SUBMISSION PM & DC BROADHEAD

INVERARY PARK, 40 BROADHEAD LANE, BUNGONIA

OBJECTION TO ARDMORE PARK QUARRY MODIFICATION (MP 07-0155 Mod 3)

AIR QUALITY (DUST)

Winds turning W 2.01pm 16/2/18

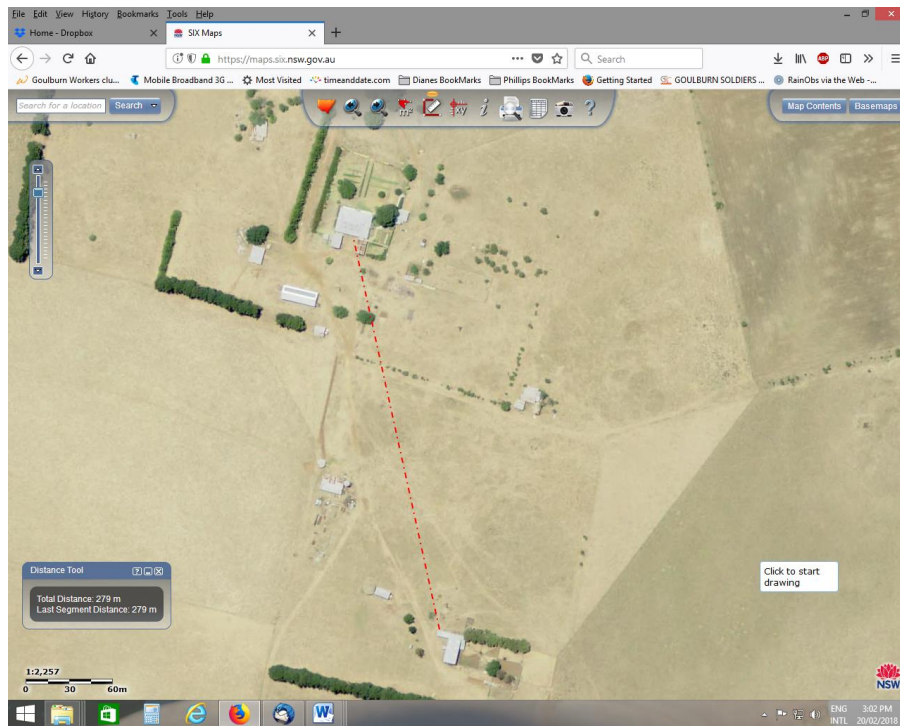
To increase these hours to 5.00am - 10.00pm Monday to Friday and 5.00am - 5.00pm Saturdays would mean that neighbours would have to put up with even more dust for 17 hours a day. With strong winds which are predominant in this area the dust can sweep from one direction to the next within minutes. See example in photos below, taken just last Friday 16 February 2018. Trees in the foreground are our boundary to the Ardmore Park Quarry site in the dust. (We have photos with proof of dates & times). These winds were certainly not the strongest we get here.

Figure 9 Recorded Monthly Average Dust Deposition Levels – Quarry Monitoring Network – November 2016 to October 2017

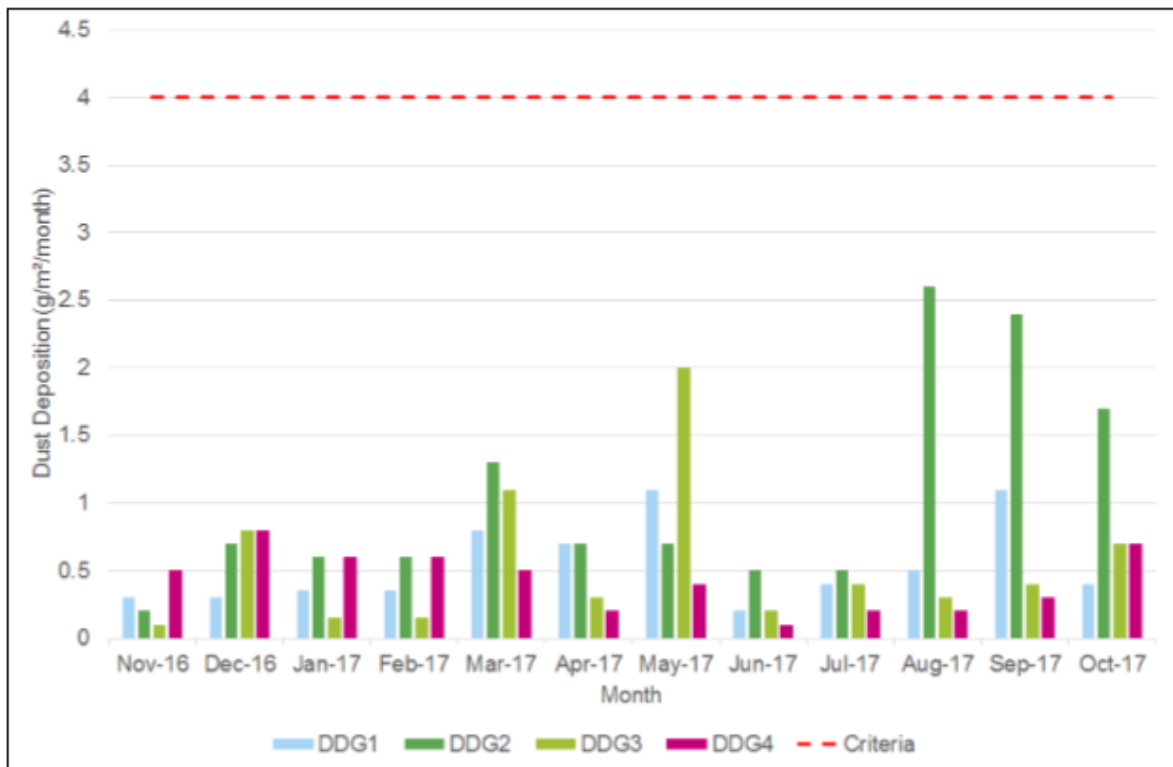
The above graph and the previous page is information supplied by Multiquip by Appendix 8 – Air Quality Impact Assessment (AQIA) to which we have studied and found some questionable information and data.

The graph above (Figure 9) in the AQIA is based on data from a 12 month period of Nov 2016 to Oct 2017. Looking at the above graph it looks as though the highest reading is just over **2.5g/m2/month** in August for DDG2 which is the Quarry. The highest reading for DDG3 (Heppleston) it looks like **2g/m2/month** in May 17. DDG4 (Broadhead) it looks like **0.8 g/m2/month** and for DDG1 (Crossley/Cole) it would be May & Sept equal at just over **1g/m2/month**. All quite low figures for the dust that we get.

Firstly we noted that there is no Report for December on the website so a complete 12 months is not there. Then we noted that in the February 2017 Report that the highest recording was for 2 - Dust Deposition (DDG1- Crossley/Cole) which Total Solids were **53** that’s 49 over the allowed limit. (See page four of this submission) This is not reflected in the graph above at all.

The dotted red line is the Maximum Total Dust Allowed and the correct information reflects the correct dust levels for this period. The Graph Supplied in the Appendix 8 Air Quality Assessment Figure 9 is misleading.

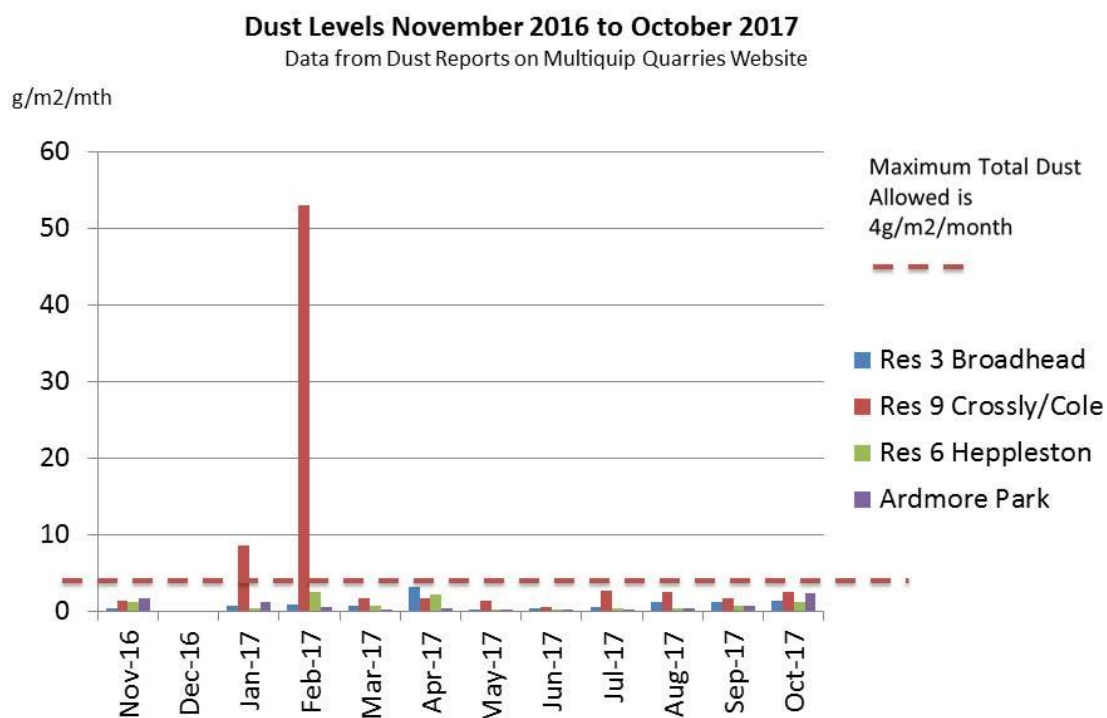
We put together a graph with the reports listed on the Multiquips Website for the same period and came up with the above graph. The highest readings for this period for Total Solids for the neighbours are as follows: DDG1 Crossley/Cole (Res9) **53g/m2/month**. DDG2 Ardmore Park **2.3g/m2/month**. DDG3 Heppleston (Res 6) **2.4g/m2/month** and DDG4 Broadhead (Res 3) **3.1g/m2/month**

Dust Levels October 2013 to July 2014
Data from Dust Reports on Multiquip Quarries Website

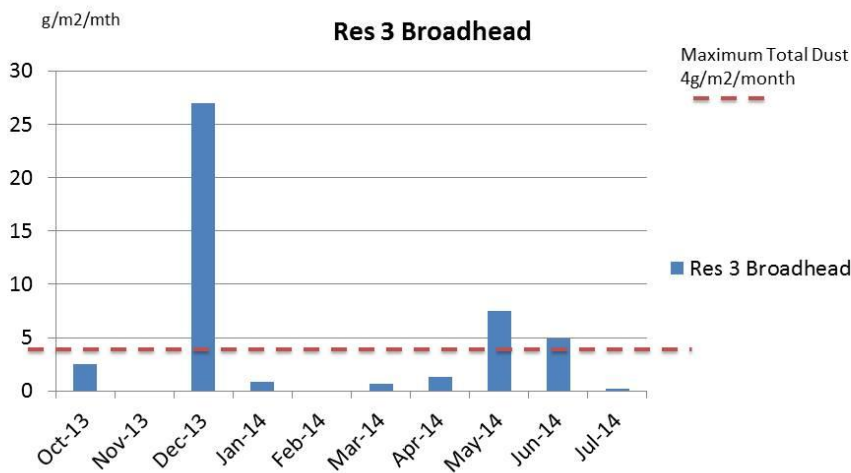
Over Maximum levels 3 times.

Dust Levels June 2015 to May 2016
Data from Dust Reports on Multiquip Quarries Website

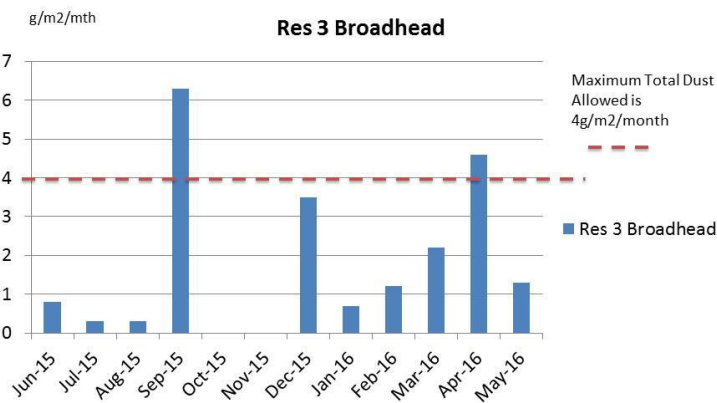
Over Maximum levels 2 times.

Dust Levels November 2016 to October 2017
Data from Dust Reports on Multiquip Quarries Website

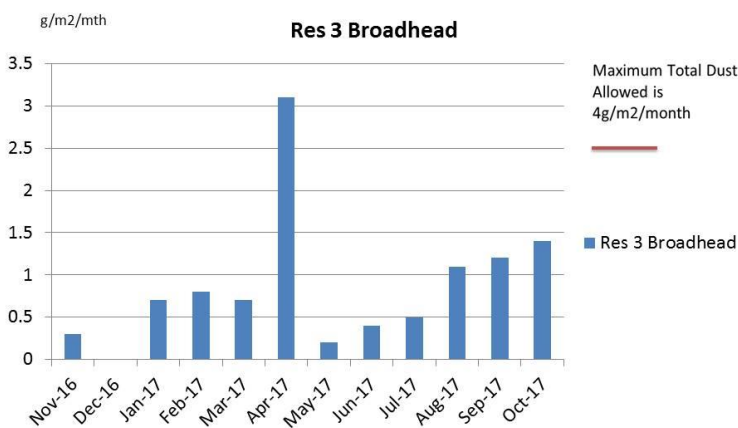
But remember they were not operating for months as they were away at another Quarry.
